SERVICE INSTRUCTION M20-83

FEBRUARY 20, 1988

- SUBJECT:** MOONEY ALTERNATE AIR DOOR MAGNETIC LATCH MODIFICATION
- MODELS/S/N EFFECTIVITY:** MOONEY MODEL M20K, S/N 25-0781 THRU 25-1151, 25-1153 THRU 25-1157, 25-1159 THRU 25-1161 AND ANY M20K AIRCRAFT, S/N 25-0001 THRU 25-0780, WHICH HAVE RETROFIT KIT 940029 (S.I. M20-71) INSTALLED.

FIGURE M20-83-1

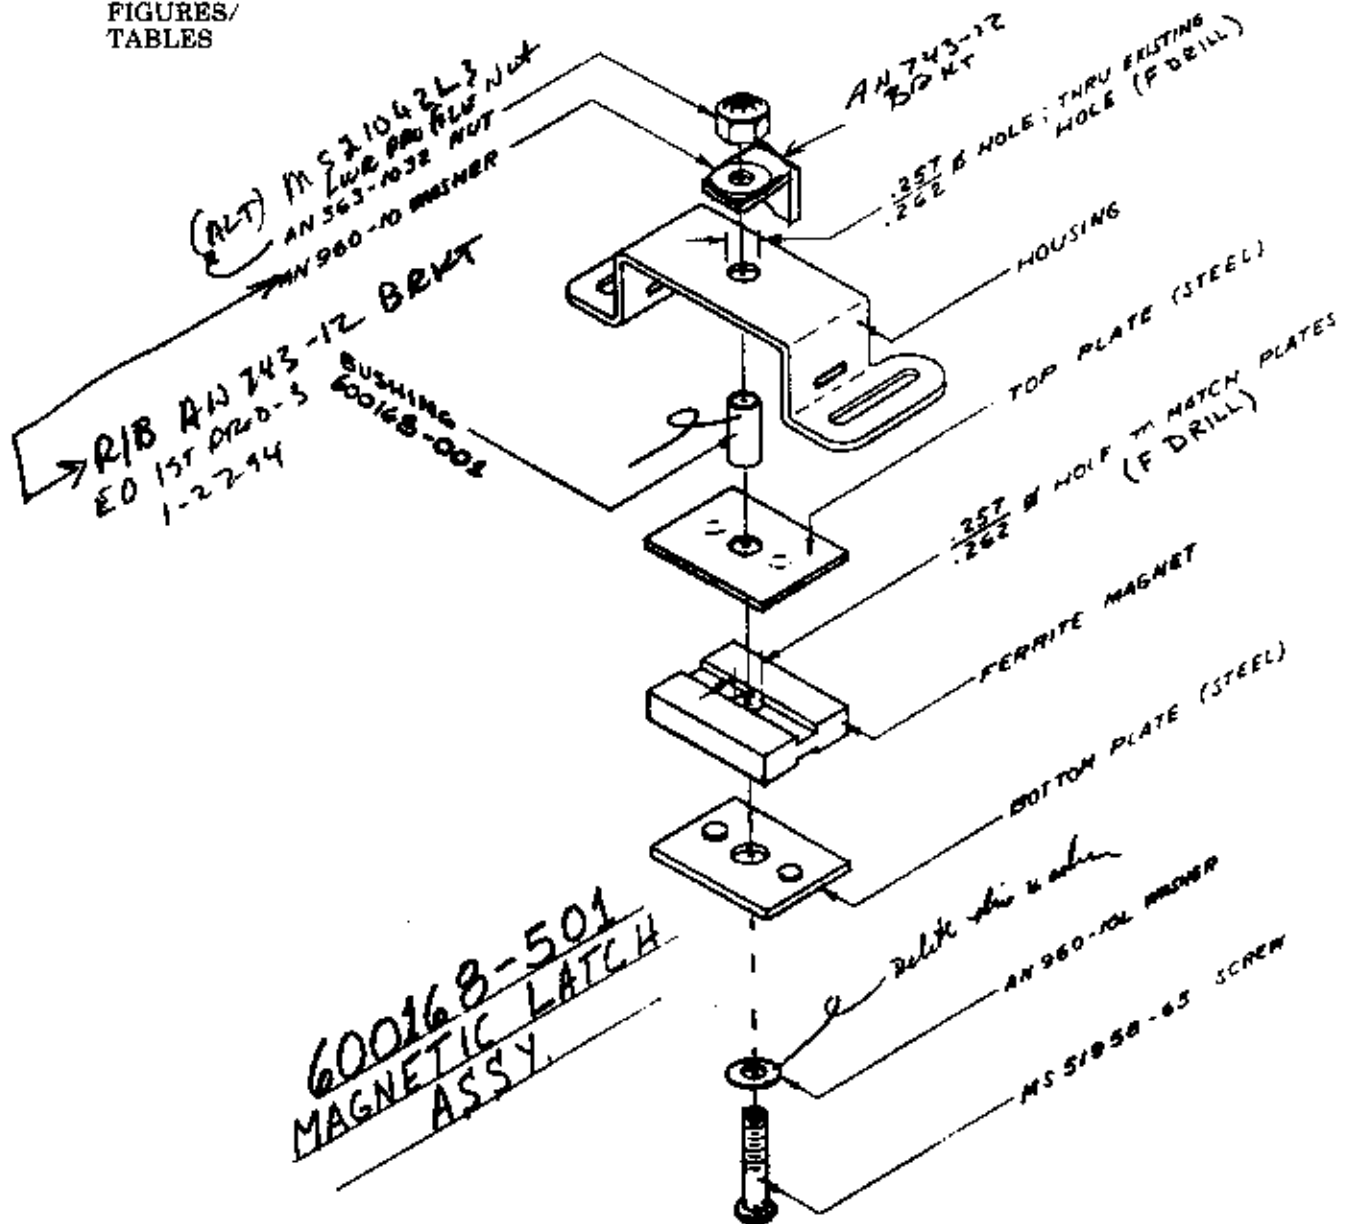
- INTRODUCTION:** The safety wire holding components of the magnetic latch assembly together have been found broken and pieces of the magnetic latch assembly have been injected into the turbo-charger causing impeller blades to be damaged. This may reduce the available power of the engine at high power settings or at high altitude.

PART NUMBER	DESCRIPTION	QTY
1. 600168-501	MAGNETIC LATCH ASSY	1
CONSISTING OF THE FOLLOWING COMPONENTS		
1. V713	MAGNECATCH (MODIFIED)	1
1. MS51958-65	SCREW (CRES)	1
2. AN969-10E	WASHER	1
3. AN960-10	WASHER	1
4. AN363-1032	NUT	1
5. 600168-001	BUSHING (CRES)	1

DO NOT SUBSTITUTE ON ANY STAINLESS STEEL COMPONENTS —

- INSTRUCTIONS:** Remove top and bottom cowling per Service and Maintenance Manual, Section 71.
- PART I**
1. Remove magnetic latch assembly from alternate air housing assembly by removing 1 screw from each side of the magnetic latch mounting flanges (2 screws).

2. Ensure that the manual alternate air door control is in the closed position and door is closed against housing.
 3. Install modified magnetic latch assembly to Alternate Air Assembly using original screws (2 ea.). Do not tighten screws until the magnetic latch assembly is in full contact with the Alternate Air Door in the closed position.

4. When assured that Alternate Air Door is FULLY closed and magnetic latch is in full contact with the door, tighten the two mounting screws to secure magnetic latch to Alternate Air Assembly.
